**Michael A. Woodbury**  
**Consulting Arborist**  
206-659-4288  
pnrc@comcast.net

**Re:** Arborist Review Tree Permit #2016-ARP-0001, Review and Recommendations  
**Site:** Deckard property, 170XX NE 33<sup>rd</sup> Ave (parcel #4023501290), Lake Forest Park, WA 98155.

**Appendix A: 2013 Aerial Site Photo  
Parcel #4023501290  
170XX NE 33<sup>rd</sup> Ave  
Lake Forest Park, WA**

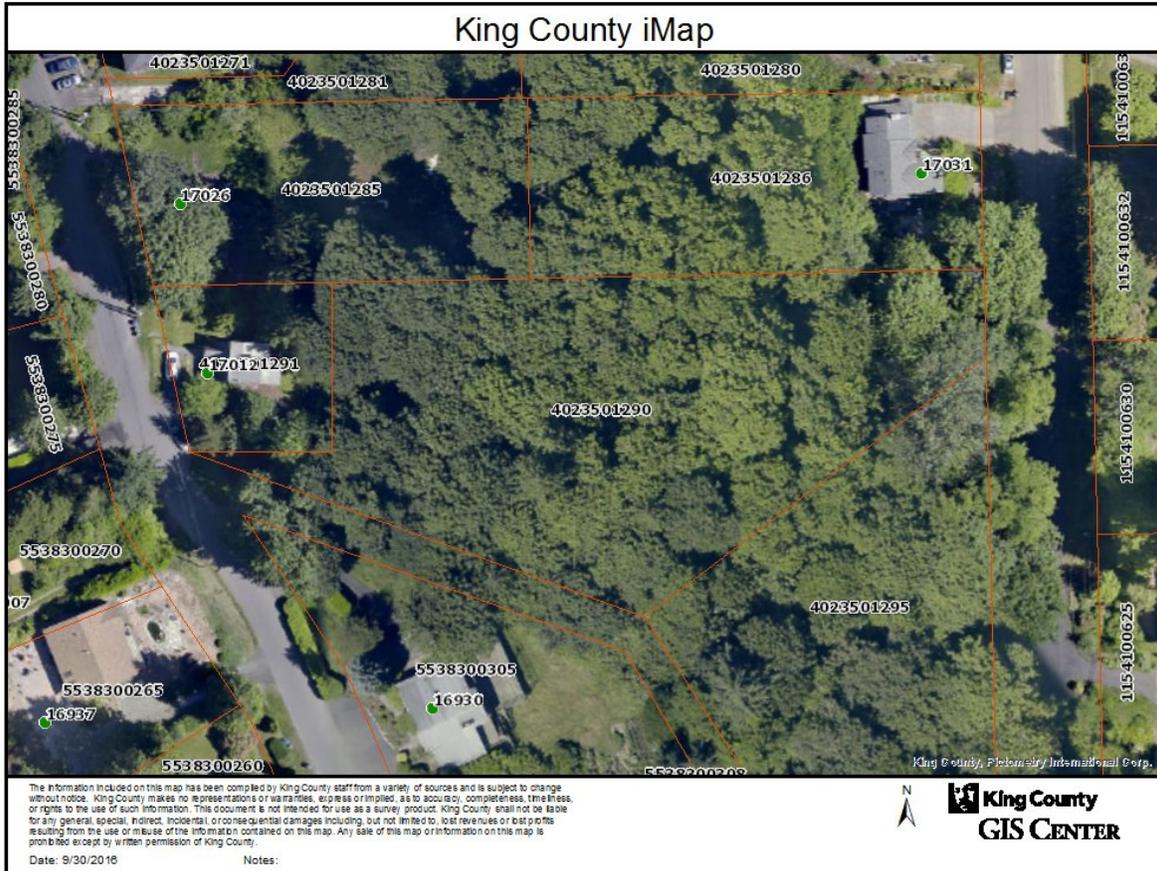
The site is an undeveloped wooded residential lot, 50,094 square feet in size, with steep terrain. The tree canopy coverage goal for this size lot, pursuant to Chapters 16.14.080, is 58 % (29,054 sq. ft.). The current canopy coverage is approximately 100% (50,094 sq. ft.), as determined either by collected tree data and/or interpretation of high resolution aerial photography, see Appendix A: *2013 Aerial Site Photo*.
